# Minutes of 89<sup>th</sup> PCC Meeting

### **MINUTES OF 89<sup>TH</sup> PROTECTION SUB-COMMITTEE MEETING HELD AT ERPC, KOLKATA ON 13.03.2020 (FRIDAY) AT 11:00 HOURS**

# 11. DR of 400 kV MPL - Maithon - 2 at MPL at 09:58 on 26-02-2020

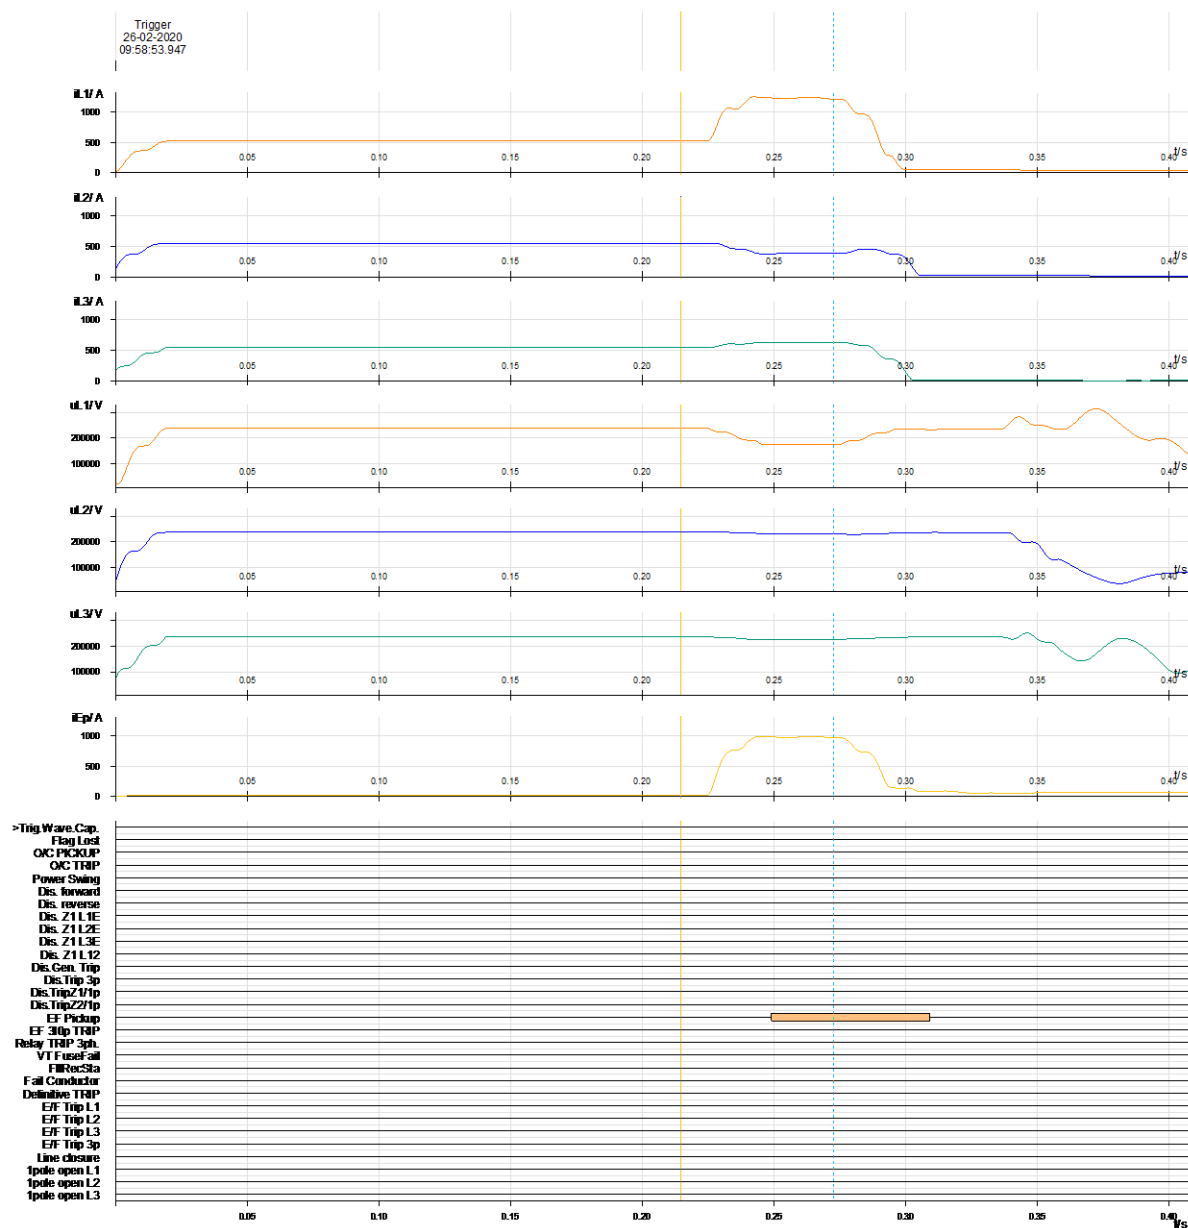
Issue: Reason of tripping not recorded in DR

## 12. DR of 400 kV Meramundali - Mendasal - 2 at Meramundali at 14:01 on 28-02-2020

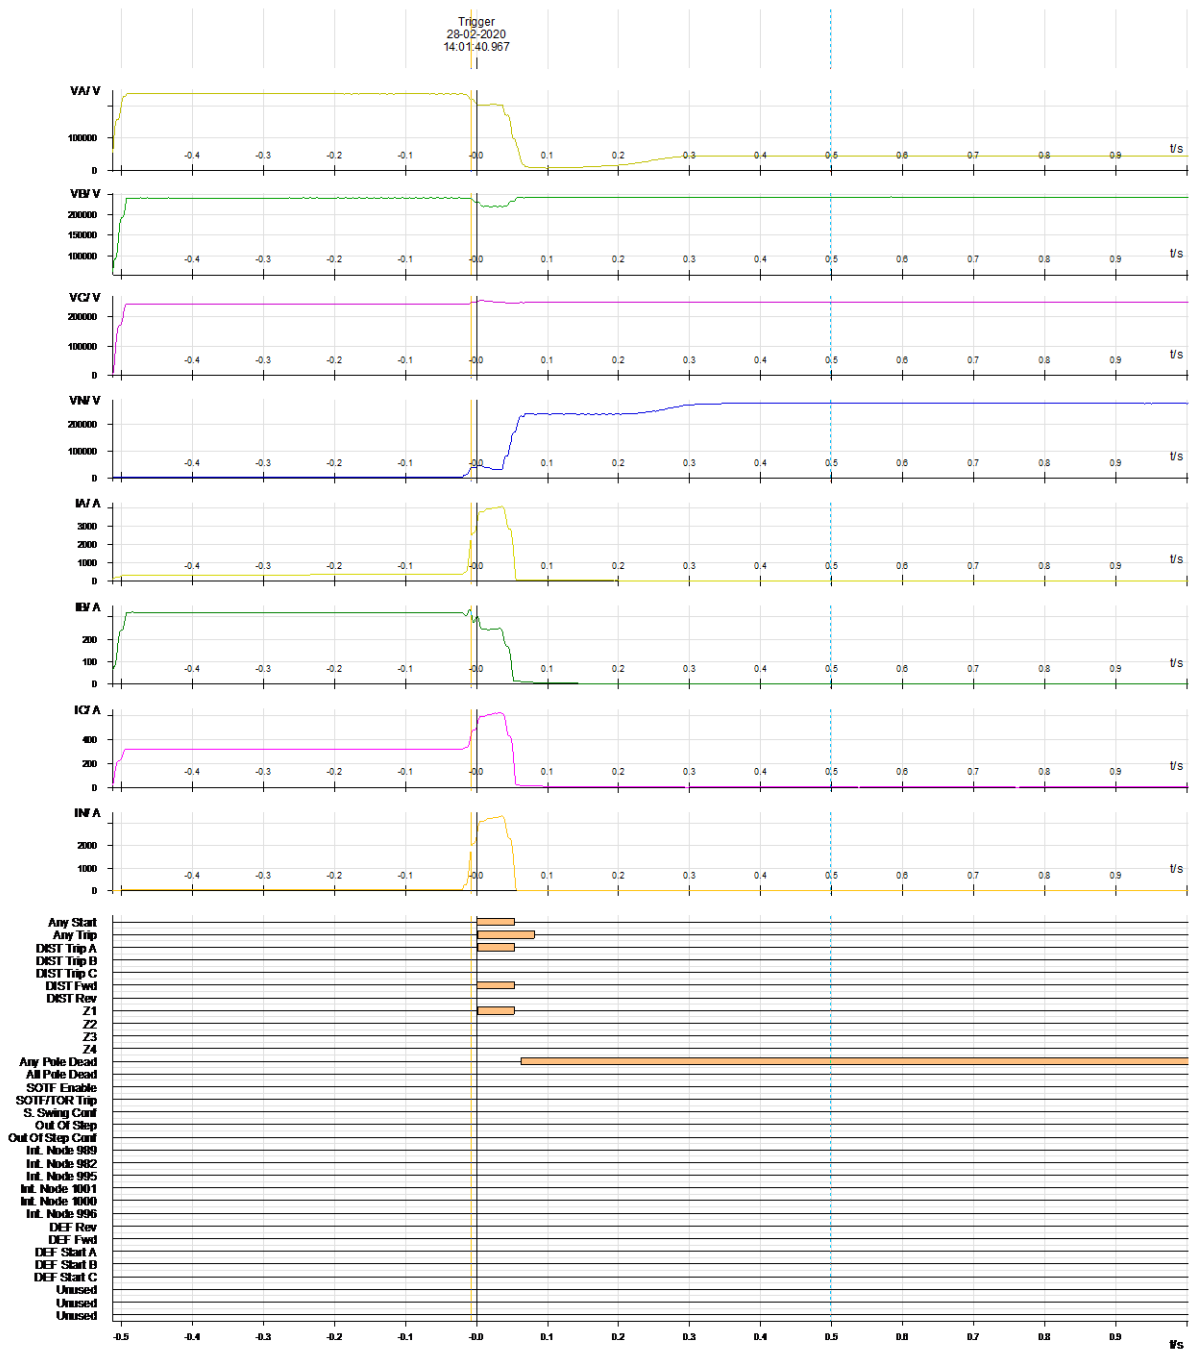
Issue: DR not properly configured, No breaker operation was recorded

# 14. DR of 400 kV Durgapur - Sagardighi - 2 at Sagardighi at 09:58 on 26-02-2020

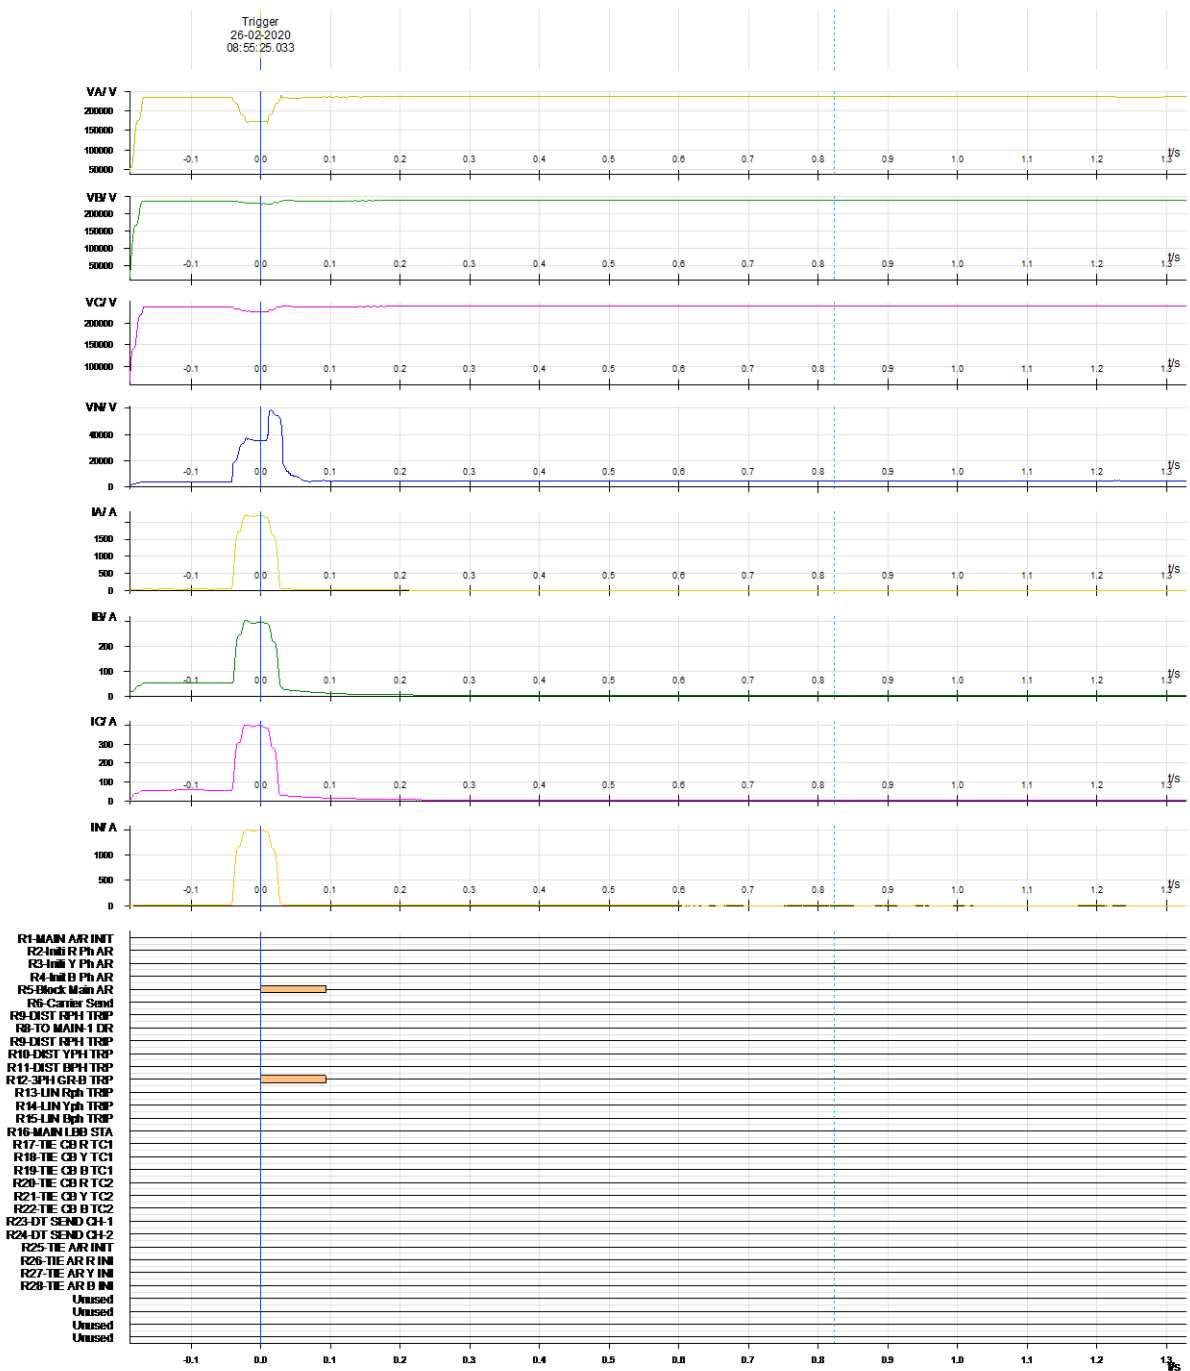
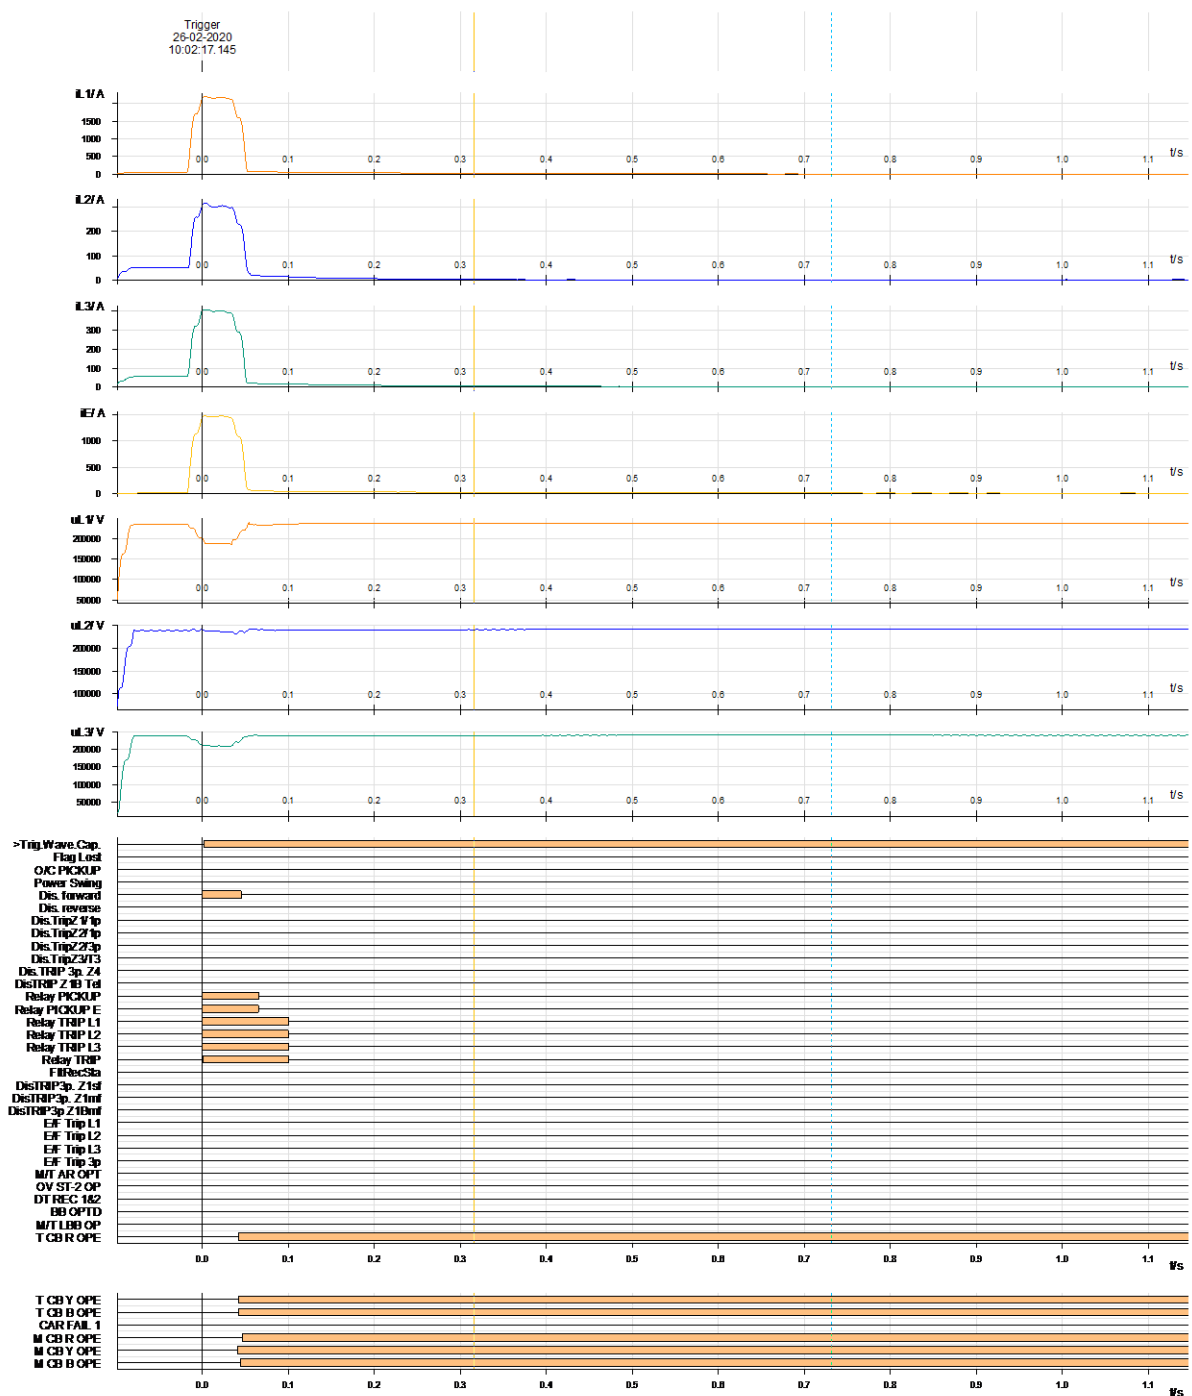
Issue: DR at Sagardighi end is not time synchronized; Time of both DR shared is different from tripping time. It is reported Z-II was triggered from Sagardighi end. Reason of tripping is not recorded.
